**VOLUME VII**

**JOHN F. RIDER**

MODEL 100  
MODEL 1000  
MODEL G  
Schematics

FIG. 1

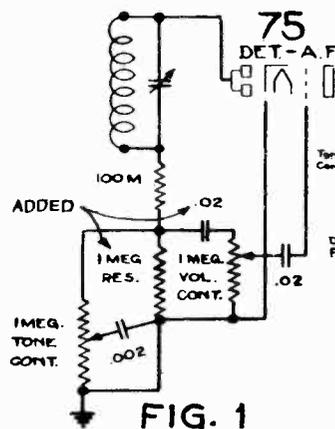
A simple circuit change will correct noisy volume controls. Its effect is to remove the d-c. diode current from the volume control and in practically all cases, it will be found that the trouble will be corrected without changing the volume control. However, if the volume control is replaced, the circuit change should be made in addition to prevent noise difficulties.

Connect a 1-megohm resistor across the outer terminals of the tone control, as indicated in Fig. 1, the schematic, and Fig. 2, the wiring diagram.

Unsolder the two leads from the ungrounded outer terminal of the volume control and solder both these leads to one side of a 0.02-mf. condenser. Connect the other side of this condenser to the volume control terminal from which the two leads were removed.

FIG. 2

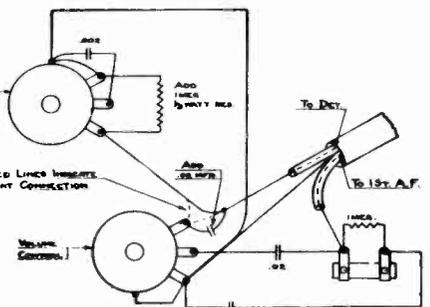
By the addition of a 1-megohm resistor and a 0.02-mf. condenser, as shown in the diagrams above, noisy volume controls are quieted in these Silvertone sets.

Corrected values of condensers in Radiola Model 66 a-f. amplifier

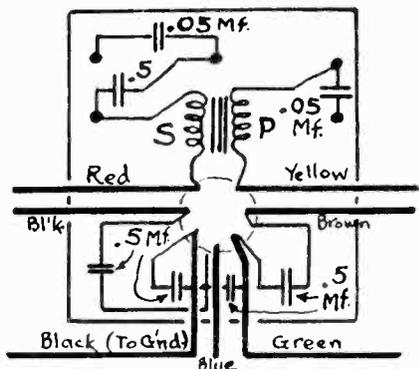
The schematic diagram of the a-f. transformer and bypass condensers contains incorrect values of capacities. Kindly make the necessary changes from

the accompanying diagram in the condensers' values in the corresponding diagram in your Manuals, where it will be found on the following pages: 1-42, \*499 and 1883 in the Radiotron-Complete.

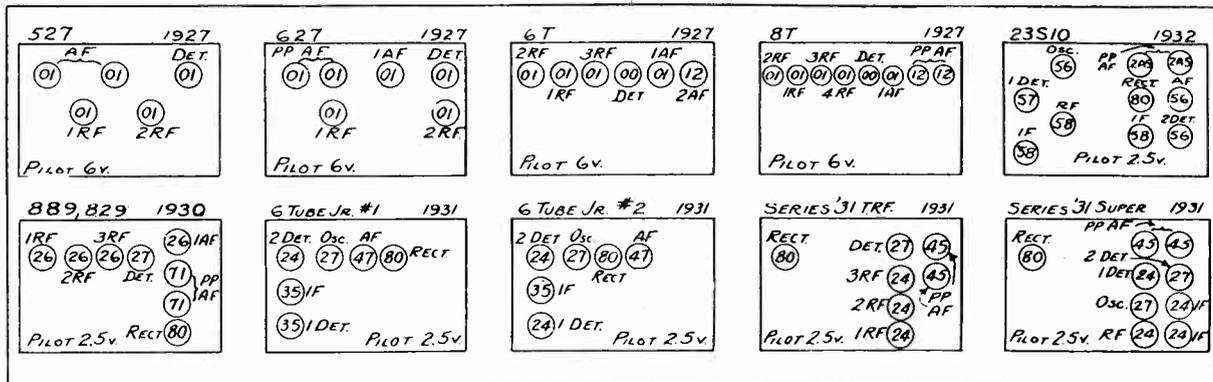
In later production runs, the pilot light circuit has been changed. See schematic diagram on Colonial page 5-40, Rider's Volume V. In place of the two 115-volt pilot lamps, a 50-ohm center-tapped resistor has been connected in the heater circuit between the 25Z5 and the 6A7. A 6.3-volt lamp (part No. R-2288) is connected across each half of this resistor. The sockets for these lamps with brackets are parts numbers R-10373-A and R-10363-F and are mounted on the variable condenser and volume control brackets respectively.

Circuit change in Colonial 603

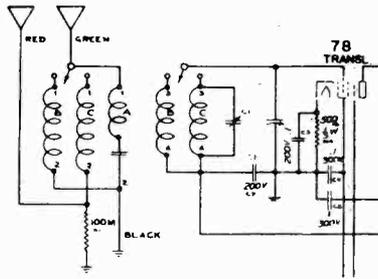
Changes have been made in the antenna circuit of this receiver, the schematic of which will be found on

removing the brown lead which goes from the antenna terminal to the wave trap inductance, L-1, and inserting the condenser between these two points. In some instances, interference in the form of "beats" may be remedied by tuning the antenna wave trap to that station. The wave trap will tune up to 700 kc.

Substituting a condenser for the choke in the i-f. amplifier improves selectivity of Model 1650.

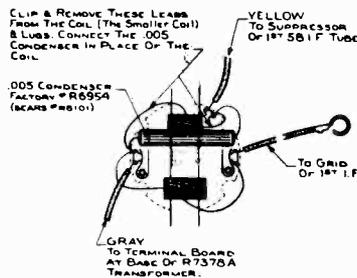
The selectivity of this set can be improved by disconnecting the two leads to the small choke coil in the 1st i-f. circuit and inserting in its stead a 0.005-mf. fixed condenser. (This choke coil is in parallel with the 20,000-ohm re-

sistor in the input circuit of the 58 i-f. tube. See *Rider's Volume VI, Sears page 6-7.*) After this substitution, the i-f. stages must be re-aligned with an oscillator. This re-balancing is very important, as the effect of the change will be lost if it is not done. See accompanying sketch for locations of coil to be removed and condenser to be substituted.

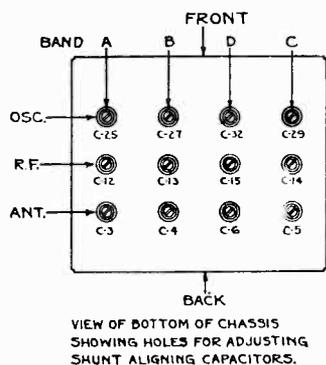
Since Volume V of Rider's Manual has gone to press, we have learned of the production of what is known as the Stromberg-Carlson 68-X. Basically, this receiver is the same as the model 68, which is shown in Rider's Volume V, pages 5-5 to 5-10, inclusive. However, the X models, which can be identified by an "X" following the serial number, incorporate certain changes. First, the secondary winding of the oscillator band A transformer contains a .00045-mfd. fixed condenser in shunt with the series trimmer, or in shunt with C-26.

Second, a 10,000-ohm fixed resistor is inserted into the common lead joining the band B and band C secondary windings in the r-f. tube grid circuit. Third, a fixed condenser has been added between the common lead connecting the band A and band B secondaries of the r-f. input transformer, and ground. Fourth, the fixed condenser C-24, located between the common lead joining all of the oscillator primary windings and ground has been changed from .1 mfd. to .05 mfd. The location of the twelve shunt aligning condensers is shown in the accompanying illustration. The numbers correspond to the designating numbers shown upon the schematic and selector chassis wiring.

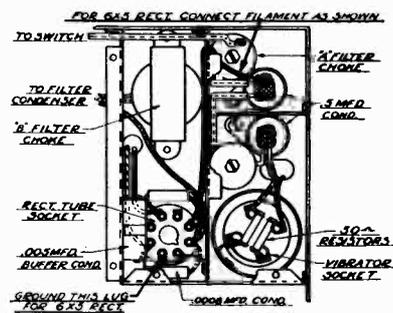
We have been advised by the manufacturer that intermittent operation of their Motorola Golden Voice models, is due to low battery voltage delivered to the set from the car's battery. Check all connections between the car battery and the radio set to avoid undue voltage drop in the car wiring, as the OZ-4 rectifier tube will fail to start

and fail to operate on a battery voltage of less than 5½ volts.

The OZ-4 tube requires 15 milliamperes or more of drain to produce ionization and proper rectification in this tube, and on battery voltages of less than 5½ volts the plate current drain of the receiver is insufficient to provide the 15 milliamperes starting current: Should the car wiring and the condition of the car battery indicate that at times the voltage may fall below 5½ volts, replace the OZ-4 rectifier tube with a 6X5 metal filament type rectifier.

Condenser banks of Stromberg Model 29

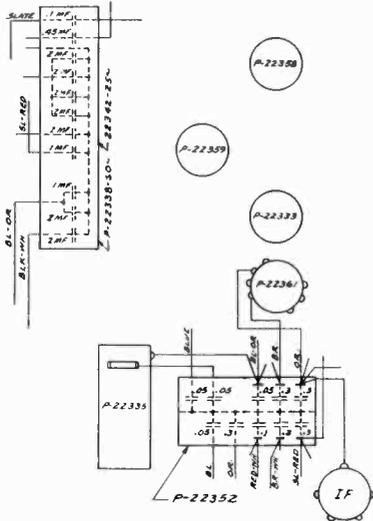
The chassis wiring diagram of this model, which appears on page 2-15 of *Rider's revised Volume II*; page 614-R of the early edition; and page 2401 of the *Rider-Combination Manual*, is not clear in one or two places. So that no doubt will be in your mind when checking over two of the condenser banks,

we are showing herewith enlarged drawings of the bank having eleven condensers, in the upper right-hand side of the diagram, and the nine-condenser bank that is shown in about the middle of the page. You can identify their positions on the wiring diagram by the apparatus in the vicinity and by the color and position of the leads. Notice that the top of the sketch shown here goes to the right-hand side of the diagram in your Manual.

The bottom view of the chassis used in A-K. Models 145 and 325 of the late type

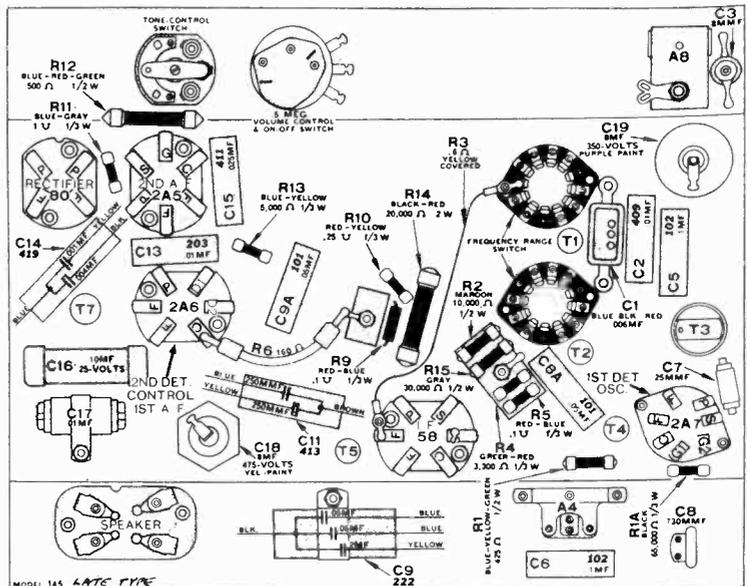
The schematic diagram shown on page 5-7 of *Rider's Volume V* is for the early model but the note at the bottom of the diagram covers the changes that were made in the late model. The elimination of the condenser, C4, in the frequency-changing switch in the late models necessitated a rearrangement of the parts. The chassis layout for the late model is shown in the accompanying illustration.

Values of resistor strip and volume control of Radiola 62

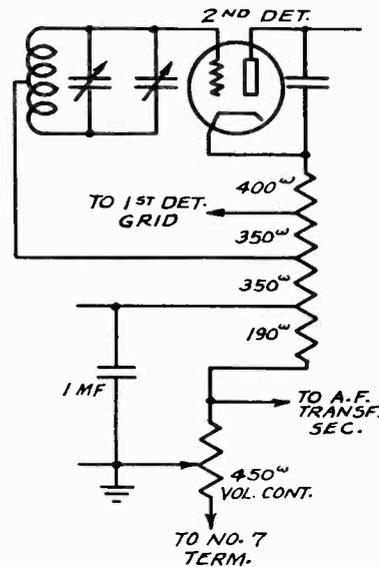
The values of the tapped resistor strip and the volume control of the Radiola 62 were omitted from the manufacturer's schematic. These values are shown in the accompanying illustration. The part

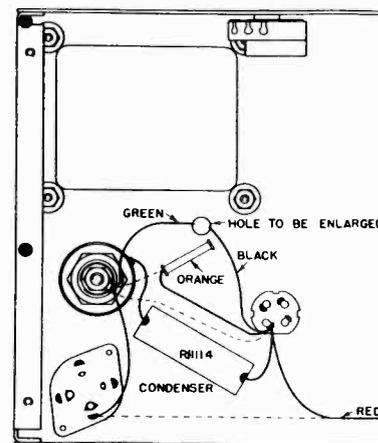
Any trouble due to hum in these models can be eliminated by performing the following operations, the purpose being to add an additional section of filtering to the power supply.

Make the wiring changes indicated in the illustration. The dotted lines represent the original wiring, which is to be changed and the solid lines show the new connections. Note that a new part, a 2-mf., 440-volt, dry electrolytic condenser, Part No. R11114, is added.
